**APPLICATION FOR PERMISSION UNDER SECTION 16 TOWN PLANNING  
APPLICATION FOR PROPOSED MINOR RELAXATION OF PLOT RATIO RESTRICTION  
FOR PERMITTED FLAT WITH SHOP AND SERVICES AND SOCIAL WELFARE  
FACILITY (RESIDENTIAL CARE HOME(S) FOR THE ELDERLY) IN "RESIDENTIAL  
(GROUP A)" ZONE IN LOT NO. 3678 in D.D. 120, YUEN LONG, NEW TERRITORIES**

**Town Planning Application No. A/YL/319 – Submission of Further Information**

**Proposed Minor Relaxation of Plot Ratio Restriction for Permitted Flat with Shop and Services and Social Welfare Facility (Residential Care Home for the Elderly) Uses in “Residential (Group A)” Zone at Lot 3678 in D.D. 120, Yuen Long, New Territories (Application No. A/YL/319)**

**SCHEMATIC ELEVATION (FACING PAU CHEUNG SQUARE)**

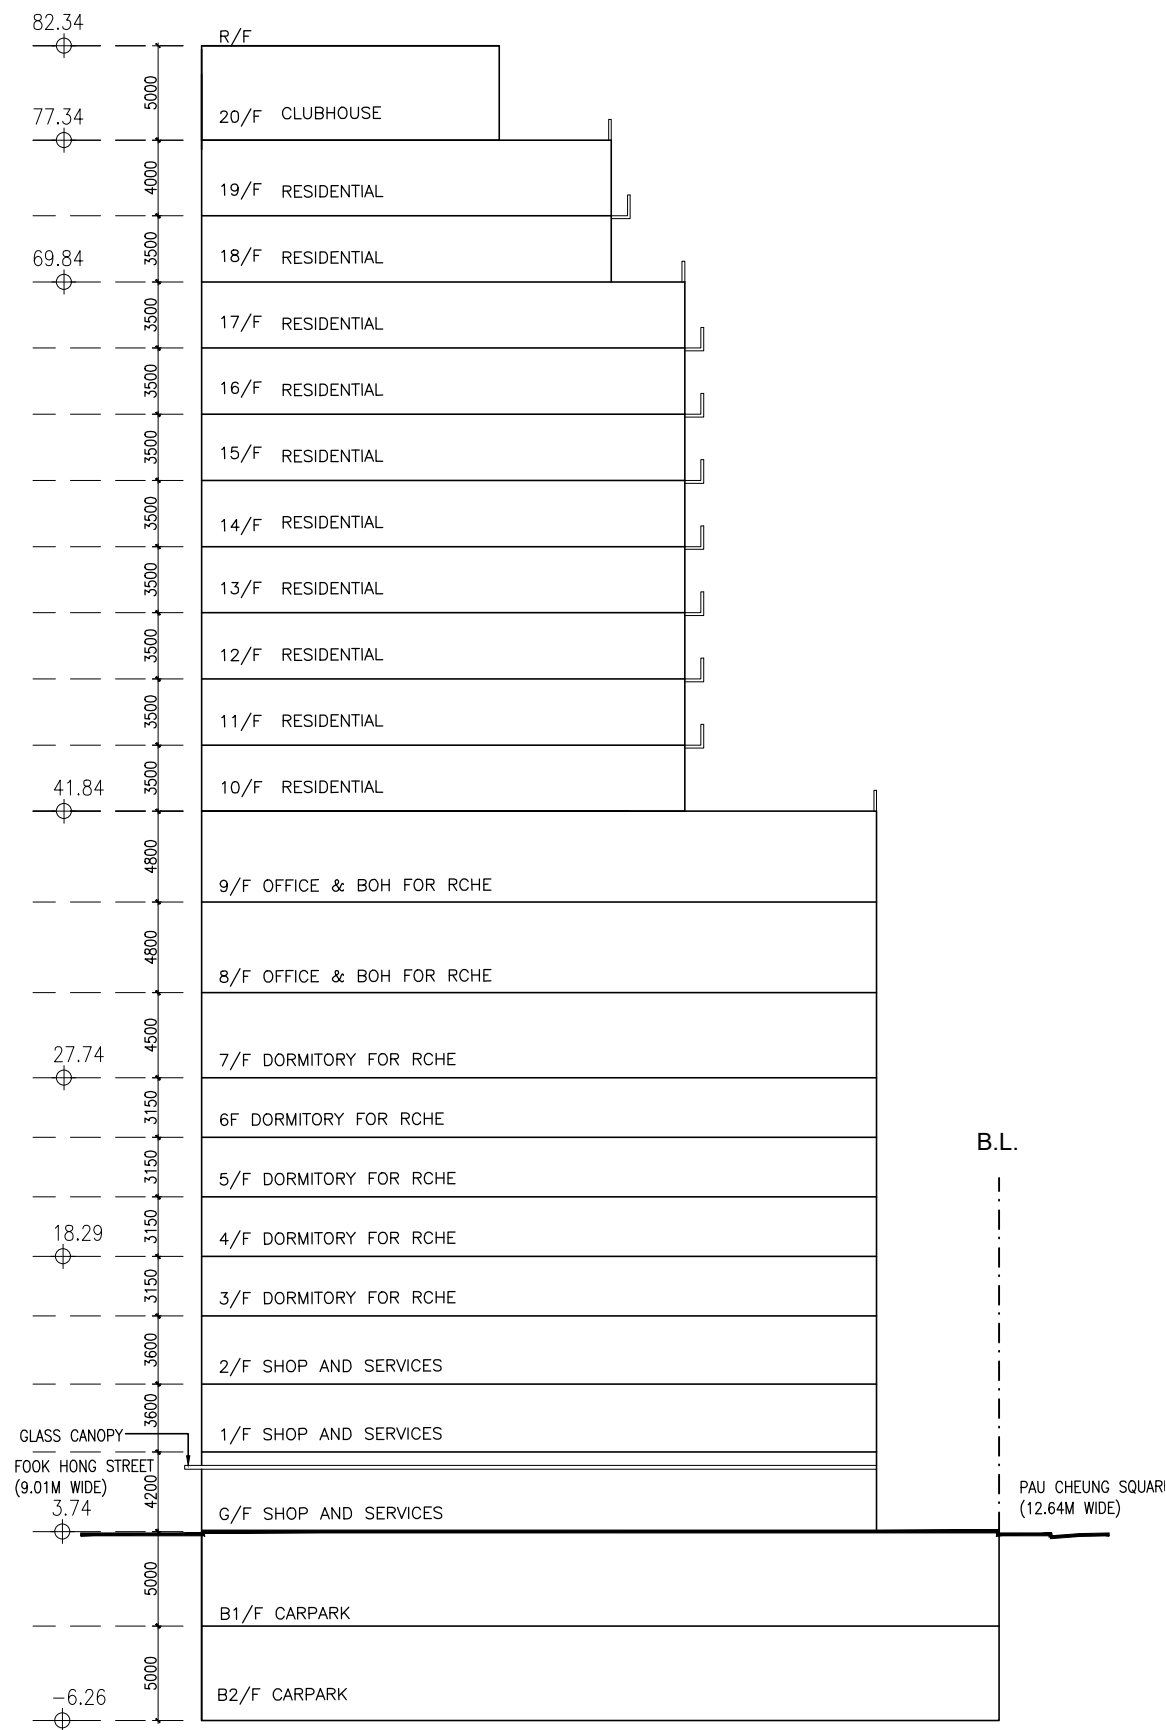
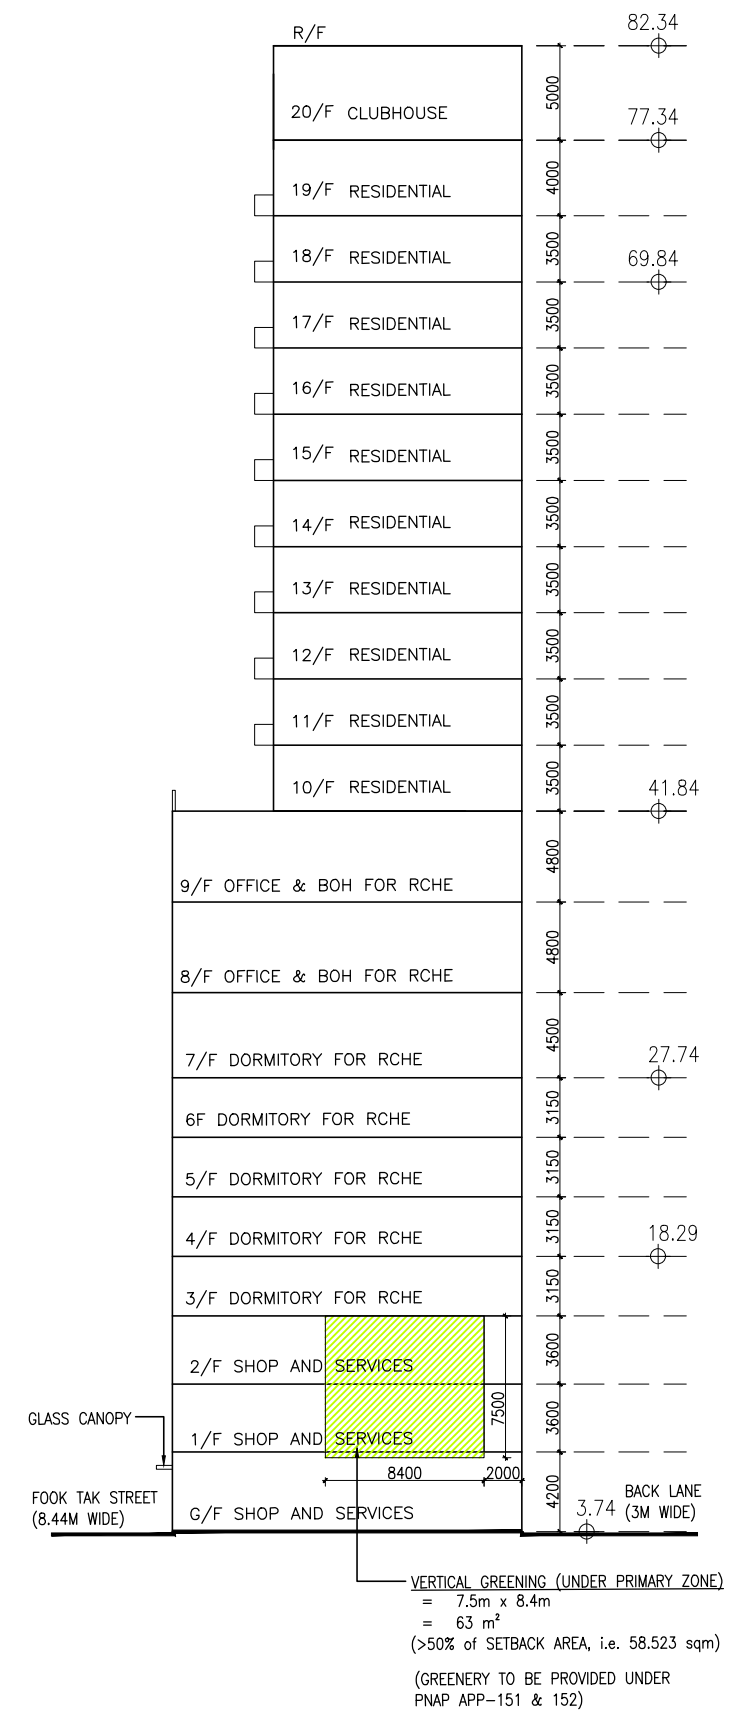
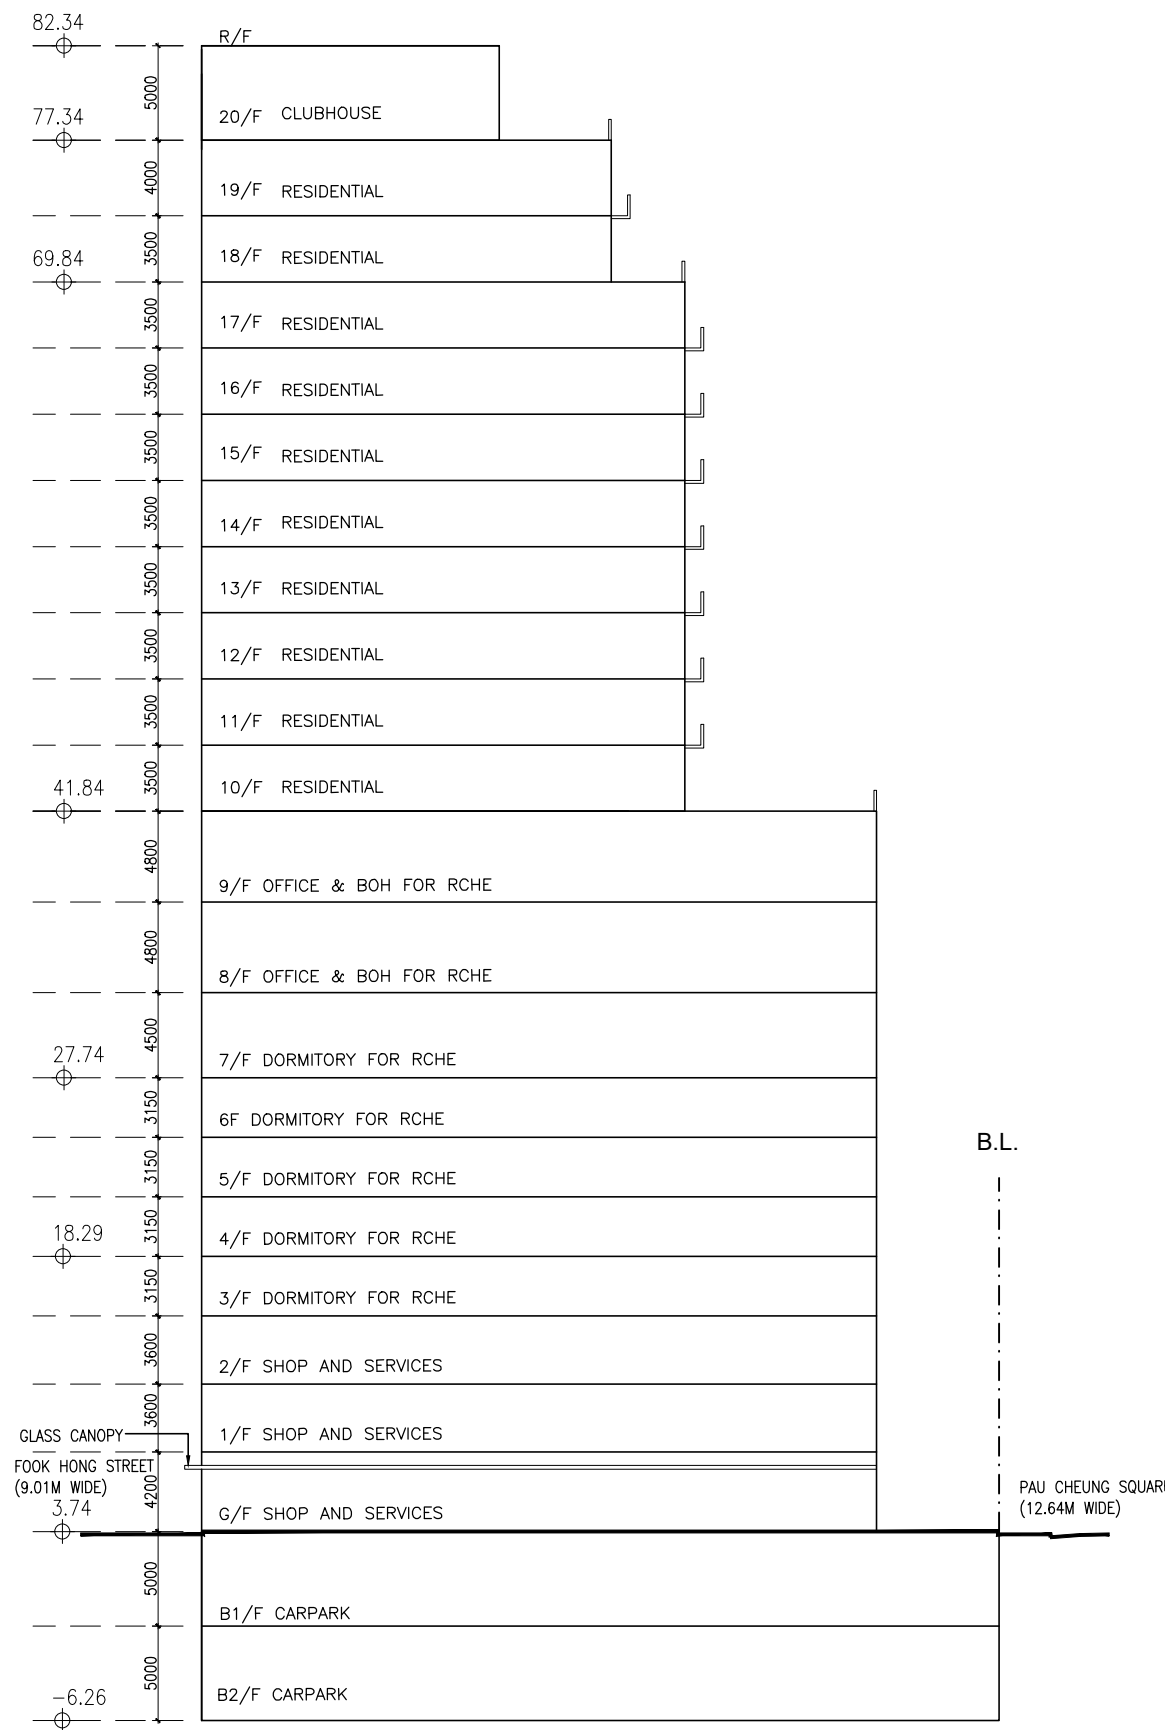
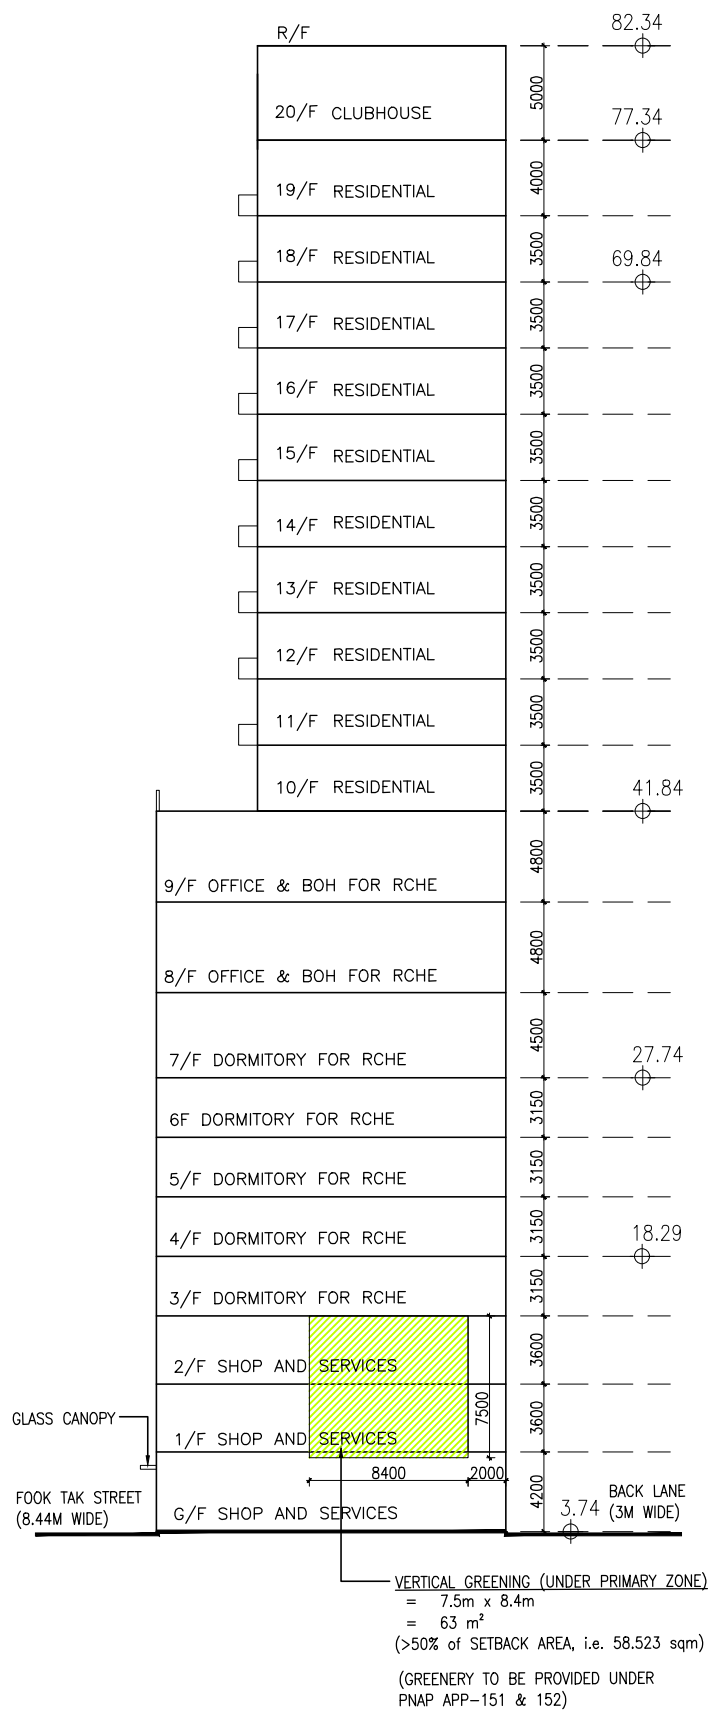
| <p>a) While the proposed building height (BH) is 78.6mPD as indicated in Table 4.1 - Major Development Parameters of the Supplementary Planning Statement, it should be an absolute BH of 78.6m above ground as shown on Drawing No. GBP013 - Schematic Section. Besides, as 3/F and above is proposed for RCHE and residential uses (which are presumably the domestic part of the proposed composite building), it seems that the proposed site coverage (SC) of not more than 85% would exceed the permitted SC in the First Schedule of the Building (Planning) Regulations.</p> | <p>It is noted that the mean street level at ground level is 3.74mPD, please find the revised schematic section and schematic elevation in <b>Attachment 2</b> (Drawing No. GBP013).</p> <p>Please note that the Site is classified as Class C and the proposed SC of the non-domestic premises would not exceed 85% according to the First Schedule of the Building (Planning) Regulations.</p> |
| <p>a) Noting the Schematic Elevation (Drawing No. GBP013) and para. 5.9 "Vertical greening will be proposed on</p>   | <p>Please find <b>Attachment 4</b> for indicating the proposed plant species for vertical greening,</p>  |

| <p>the external wall of the building facing the Tuen Long Pau Cheung Square...”, the applicant should provide details including proposed plant species for vertical greening for consideration.</p>   | <p>subject to detailed design after the planning stage.</p>  |

**FIGURE 2.3**  
**BUFFER DISTANCE BETWEEN THE**  
**PROPOSED DEVELOPMENT AND THE**  
**NEARBY ROAD NETWORK**

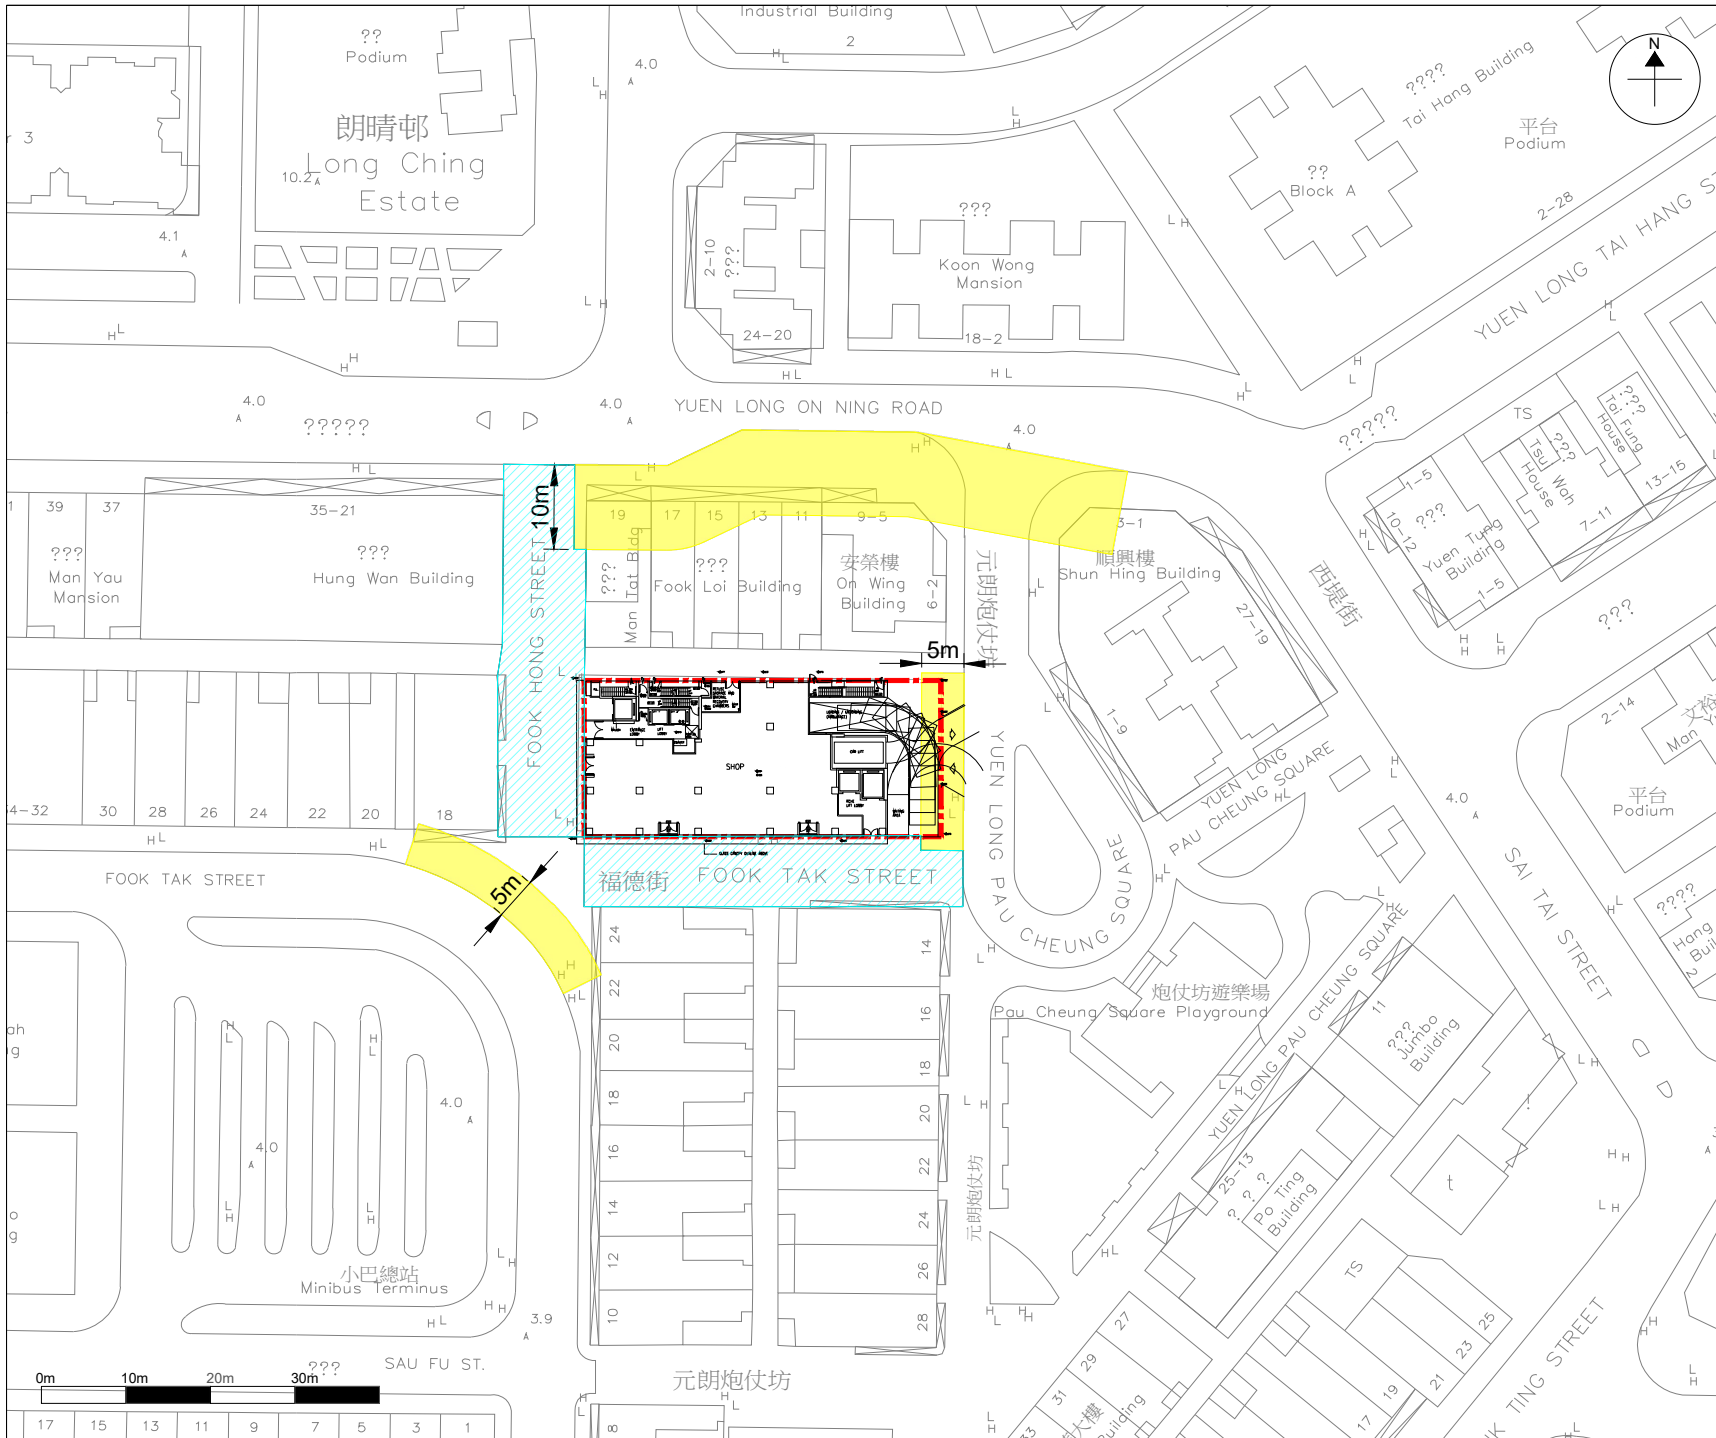
| <p>k) Figure 2.3 -</p> <p>(i) Please provide a remark to state that no air-sensitive uses including openable window, fresh air intake and recreational uses in open space shall be located within the buffer zones.</p>   | <p>(i) A Remark is added on Figure 2.3 of the Revised Environmental Assessment Report (<b>Attachment 3</b>), stating no air-sensitive uses including openable window, fresh air intake and recreational uses in open space shall be located within the buffer zones.</p> |

| <p>(ii) Please indicate clearly on the figure that the sections of Fook Tak Street and Fook Hong Street along the project site boundary are pedestrian walkway/ footpath and hence no buffer distance is required.</p>   | <p>(ii) Fook Tak Street and Fook Hong Street along the project site are indicated and labelled as pedestrian walkway/footpath and no buffer distance is required in Figure 2.3 of the Revised Environmental Assessment Report (<b>Attachment 3</b>)..</p> |
